Item ID: D119-646-041 Accept ***N900040100*** Setup Start ***NS1***
Revision ID: URF15-560 Stop ***NS2***
Item Name: Replacement Skidtube with Wearpads, Fits LH or RH
Start Date: 3/21/2016 Start Qty: 1.00 ***1*** Cust Item ID:
Required Date: 3/22/2016 Req'd Qty: 1.00 ***1*** Customer: CAGUS02
Reference: RMA RA112268

DART SERVICE INSTRUCTION

TO AMEND INSTALLATION INSTRUCTIONS IIN-D119-646 REV. C
AND INSTRUCTIONS FOR CONTINUED AIRWORTHINESS ICA-D119-646 REV. 2
REF FAA STC: SR02024SE
REF EASA STC: 10040294

The purpose of this Dart Service Instructions is to add D119-646-313/-314 Skidtube Protector Kit to make the D119-646-011/-012/-111/-112/-211/-212 Skidtube Kits compatible with the 109-0812-68-105 Hoist Structural Provision Kit and the 109-0816-18-301 Rappelling Kit. The D119-646-313 Skidtube Protector, LH replaces the 109-B710-05-201 kit and the D119-646-314 Skidtube Protector, RH replaces the 109-B710-05-202 kit.

FIGURE 1: D119-646-314 SKIDTUBE PROTECTOR KIT, RH (SHOWN)
(D119-646-313 SKIDTUBE PROTECTOR, LH (OPPOSITE))
(SHOWN INSTALLED ON D119-646-011/-012/-111/-112 SKIDTUBES)

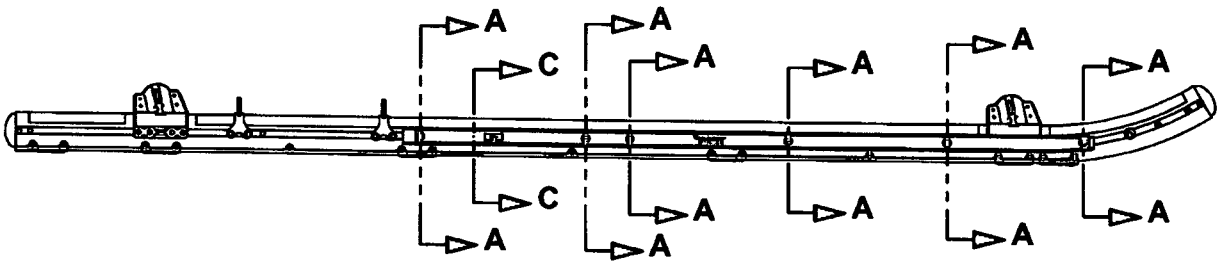
- 2.13 Install D5369-2 Cable Guard on the RH side of the aircraft using 6x AN3-47A bolts, 6x D5374-1 Bushings, 6x D4506-3 Washers, 12x NAS11490D332J washers, 6x MS21042L3 nuts as shown in Figure 1 Section A-A. Torque bolts to 15-25 in-lbs (1.7-2.8 N-m).

- 2.14 Install D5369-1 Cable Guard on the LH side of the aircraft using 6x AN3-47A bolts, 6x D5374-1 Bushings, 6x D4506-3 Washers, 12x NAS11490D332J washers, 6x MS21042L3 nuts as shown in Figure 1 Section A-A. Torque bolts to 15-25 in-lbs (1.7-2.8 N-m).

FIGURE 2: D119-646-314 SKIDTUBE PROTECTOR KIT, RH (SHOWN)
(D119-646-313 SKIDTUBE PROTECTOR, LH (OPPOSITE))
(SHOWN INSTALLED ON D119-646-211/-212 SKIDTUBES)

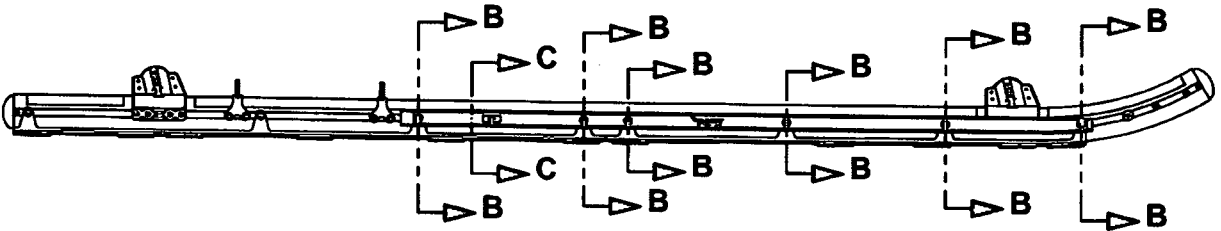
- 3.14 Install D5369-2 Cable Guard on the RH side of the aircraft using 6x AN3-50A bolts, 6x D5374-1 Bushings, 6x D3904-1 Washers, 6x MS21042L3 nuts as shown in Figure 2 Section B-B. Torque bolts to 15-25 in-lbs (1.7-2.8 N-m).

- 3.15 Install D5369-1 Cable Guard on the LH side of the aircraft using 6x AN3-50A bolts, 6x D5374-1 Bushings, 6x D3904-1 Washers, 6x MS21042L3 nuts as shown in Figure 2 Section B-B. Torque bolts to 15-25 in-lbs (1.7-2.8 N-m).

SECTION C-C

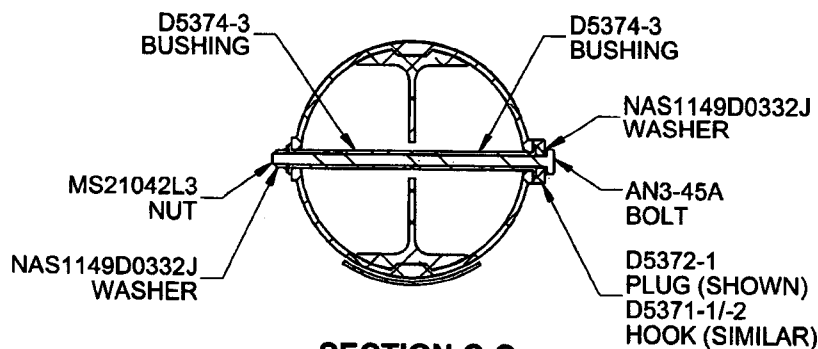
- 2.6 Vacuum the debris from inside of the skidtube. Touch up affected area using (Alodine 1200 or 1201) per MIL-DTL-5541.
- 2.7 Install 8x D5374-3 Bushings in the new holes. Seal bushings with Sikaflex-241/-291 or Proseal 890 or MIL-S-8802 Class 'B2' sealant as shown in Section C-C.

- 3.6 Vacuum the debris from inside of the skidtube. Touch up affected area using (Alodine 1200 or 1201) per MIL-DTL-5541.
- 3.7 Install 8x D5374-3 Bushings in the new holes. Seal bushings with Sikaflex-241/-291 or Proseal 890 or MIL-S-8802 Class 'B2' sealant as shown in Section C-C.

FIGURE 3: USING D5376-1 DRILLING JIG

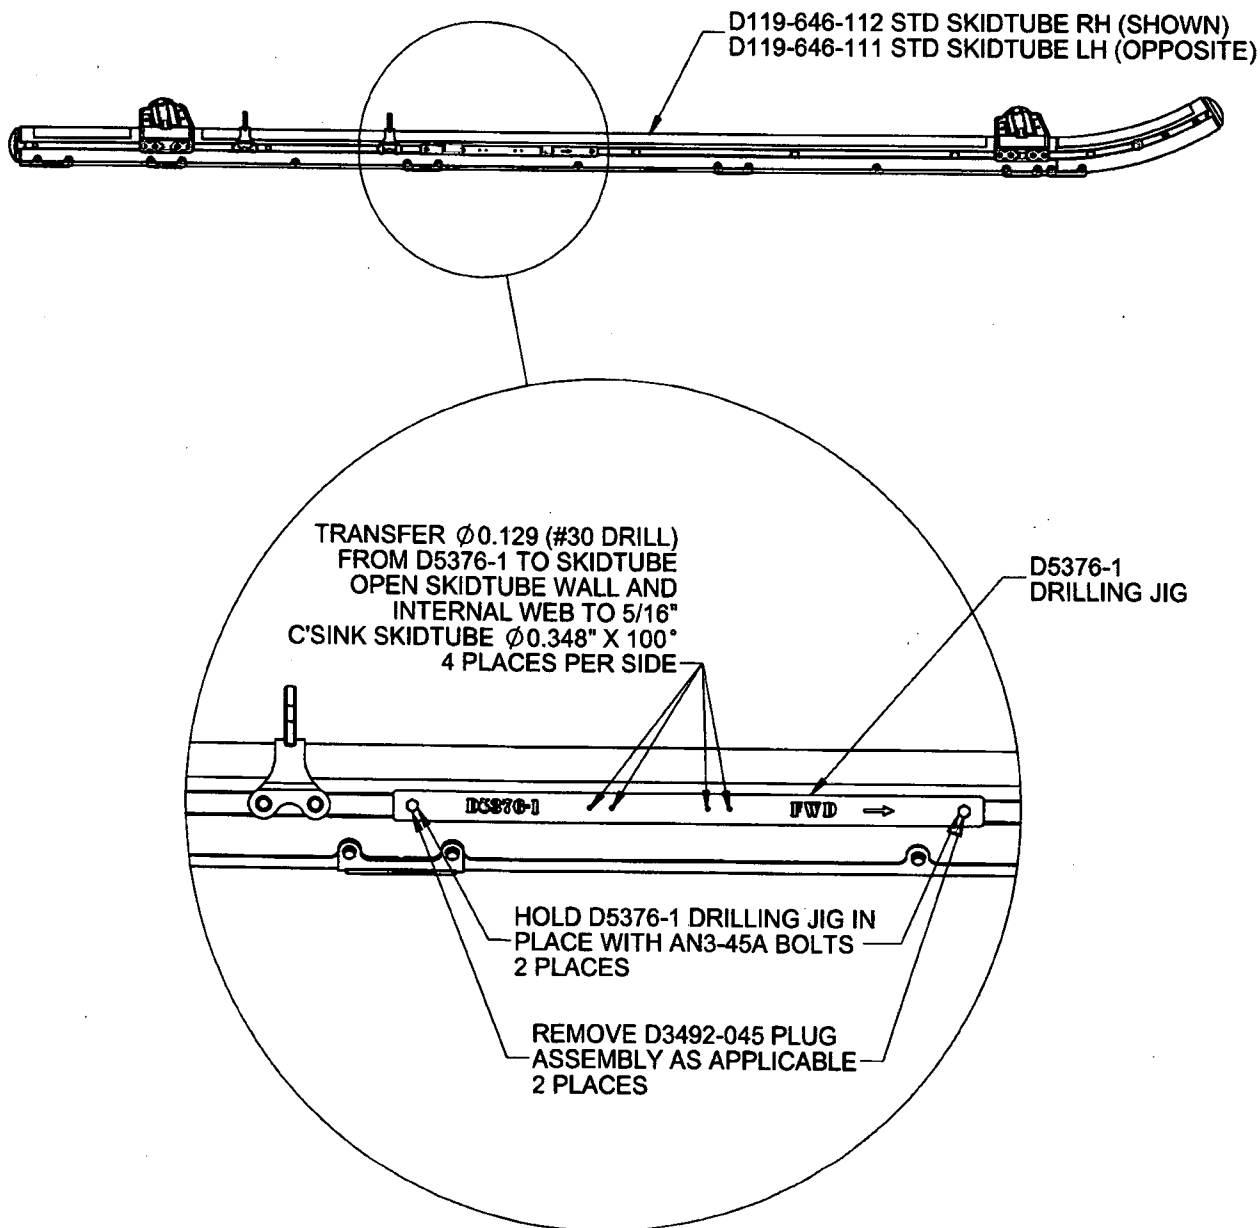
- 2.1 Remove D3492-045 Plug Assemblies from two locations on each side of the skidtube as shown in Figure 3.
- 2.2 Position D5376-1 drilling jig tool with the arrow pointing fwd as shown in Figure 3. Use 2x AN3-45A bolts to hold the jig in place. Transfer drill 4x $\varnothing 0.129$ " (#30 drill) holes from D5376-1 drilling jig to skidtube ridge as shown in Figure 3. **Caution:** Drill perpendicular to the skidtube ridge.

- 2.3 Remove drilling jig. Using a 5/16" drill, open up the pilot holes and drill through the skidtube ridge and center web inside of the skidtube. **Caution:** Drill perpendicular to the skidtube ridge.

- 2.4 Countersunk 4x 5/16" holes to $\varnothing 0.348$ " (8.84mm) x 100° as shown in Figure 3 and deburr.
- 2.5 Repeat steps 2.2 to 2.4 for the opposite side of the skidtube.

- 3.1 Temporarily remove D3849-043 Training Wearplate from aft end of the skidtube per ICA-D119-646 Section 32.
- 3.2 Position D5376-1 drilling jig tool with the arrow pointing fwd as shown in Figure 3. Use 2x AN3-45A bolts to hold the jig in place. Transfer drill 4x $\varnothing 0.129$ " (#30 drill) holes from D5376-1 drilling jig to skidtube ridge as shown in Figure 3. **Caution:** Drill perpendicular to the skidtube ridge.

- 3.3 Remove drilling jig. Using a 5/16" drill, open up the pilot holes and drill through the skidtube ridge and center web inside of the skidtube. **Caution:** Drill perpendicular to the skidtube ridge.

- 3.4 Countersunk 4x 5/16" holes to $\varnothing 0.348$ " (8.84mm) x 100° as shown in Figure 3 and deburr.
- 3.5 Repeat steps 3.2 to 3.4 for the opposite side of the skidtube.

FIGURE 4: D5372-1 PLUG INSTALLATION

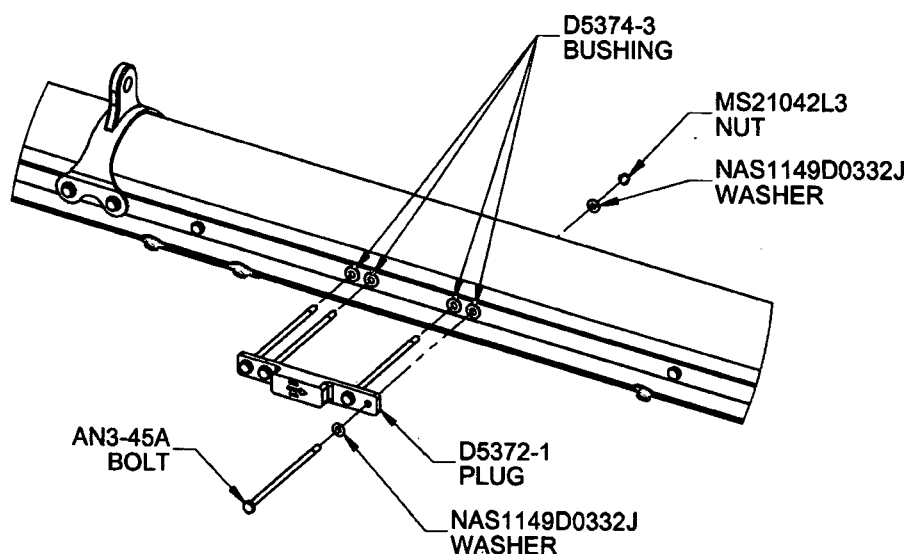
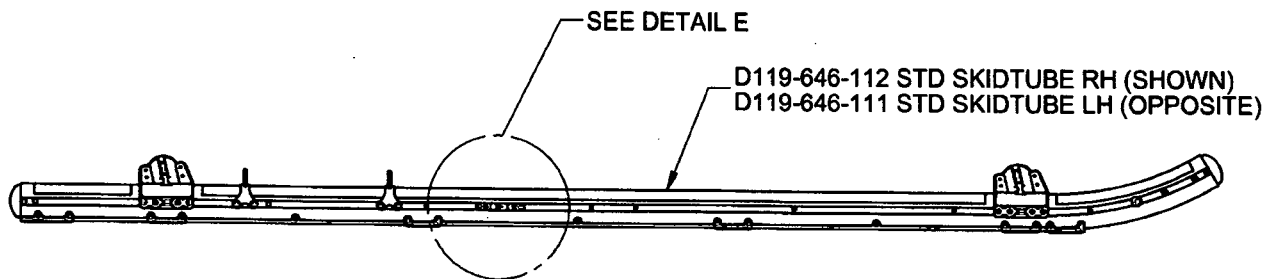
- 2.8 Remove all D3492-045 Plug Assemblies from skidtube fwd of the ground handling wheel lugs.
- 2.9 If the D119-646-314 Skidtube Protector Kit is required for hoisting operations on the RH side of the aircraft install D5372-1 Plug using 4x AN3-45A bolts, 8x NAS11490D332J washer and 4x MS21042L3 nuts as shown in Section C-C and Figure 4 Detail E. Torque bolts to 15-25 in-lbs (1.7-2.8 N-m).

- 2.10 If the D119-646-313 Skidtube Protector Kit is required for hoisting operations on the LH side of the aircraft install D5372-1 Plug using 4x AN3-45A bolts, 8x NAS11490D332J washer and 4x MS21042L3 nuts as shown in Section C-C and Figure 4 Detail E. Torque bolts to 15-25 in-lbs (1.7-2.8 N-m).

- 3.8 Remove and discard all hardware attaching the training wearplates in front of the skidtube ground handling lugs.
- 3.9 If the D119-646-314 Skidtube Protector Kit is required for hoisting operations on the RH side of the aircraft install D5372-1 Plug using 4x AN3-45A bolts, 8x NAS11490D332J washer and 4x MS21042L3 nuts as shown in Section C-C and Figure 4 Detail E. Torque bolts to 15-25 in-lbs (1.7-2.8 N-m).

- 3.10 If the D119-646-313 Skidtube Protector Kit is required for hoisting operations on the LH side of the aircraft install D5372-1 Plug using 4x AN3-45A bolts, 8x NAS11490D332J washer and 4x MS21042L3 nuts as shown in Section C-C and Figure 4 Detail E. Torque bolts to 15-25 in-lbs (1.7-2.8 N-m).

FIGURE 5: D5371-1/-2 HOOK INSTALLATION

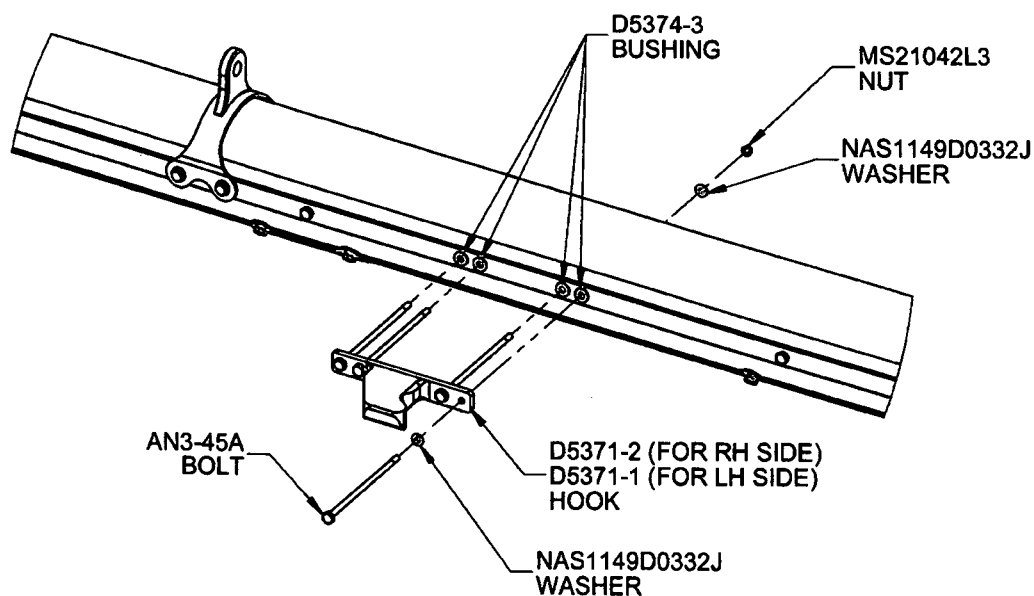
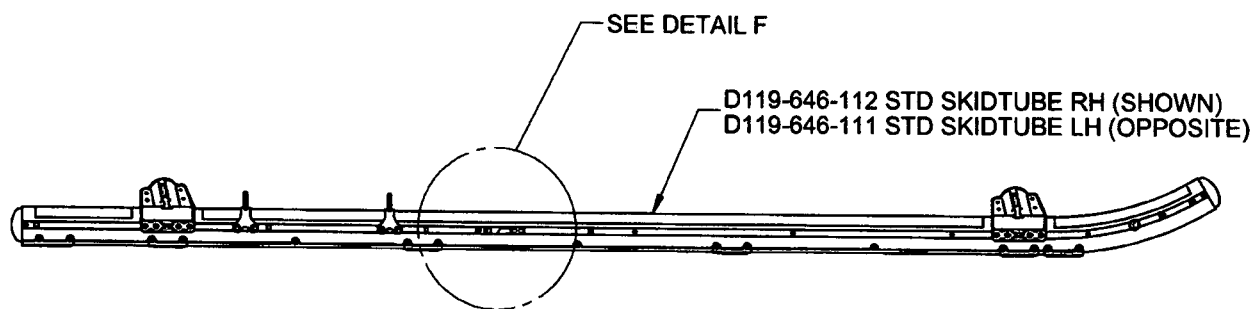
- 2.11 If the D119-646-314 Skidtube Protector Kit is required for rappelling operations on the RH side of the aircraft install D5371-2 Hook using 4x AN3-45A bolts, 8x NAS11490D332J washer and 4x MS21042L3 nuts as shown in Section C-C and Figure 5 Detail F. Torque bolts to 15-25 in-lbs (1.7-2.8 N-m).

- 2.12 If the D119-646-313 Skidtube Protector Kit is required for rappelling operations on the LH side of the aircraft install D5371-1 Hook using 4x AN3-45A bolts, 8x NAS11490D332J washer and 4x MS21042L3 nuts as shown in Section C-C and Figure 5 Detail F. Torque bolts to 15-25 in-lbs (1.7-2.8 N-m).

- 3.11 If the D119-646-314 Skidtube Protector Kit is required for rappelling operations on the RH side of the aircraft install D5371-2 Hook using 4x AN3-45A bolts, 8x NAS11490D332J washer and 4x MS21042L3 nuts as shown in Section C-C and Figure 5 Detail F. Torque bolts to 15-25 in-lbs (1.7-2.8 N-m).

- 3.12 If the D119-646-313 Skidtube Protector Kit is required for rappelling operation on the LH side of the aircraft install D5371-1 Hook using 4x AN3-45A bolts, 8x NAS11490D332J washer and 4x MS21042L3 nuts as shown in Section C-C and Figure 5 Detail F. Torque bolts to 15-25 in-lbs (1.7-2.8 N-m).
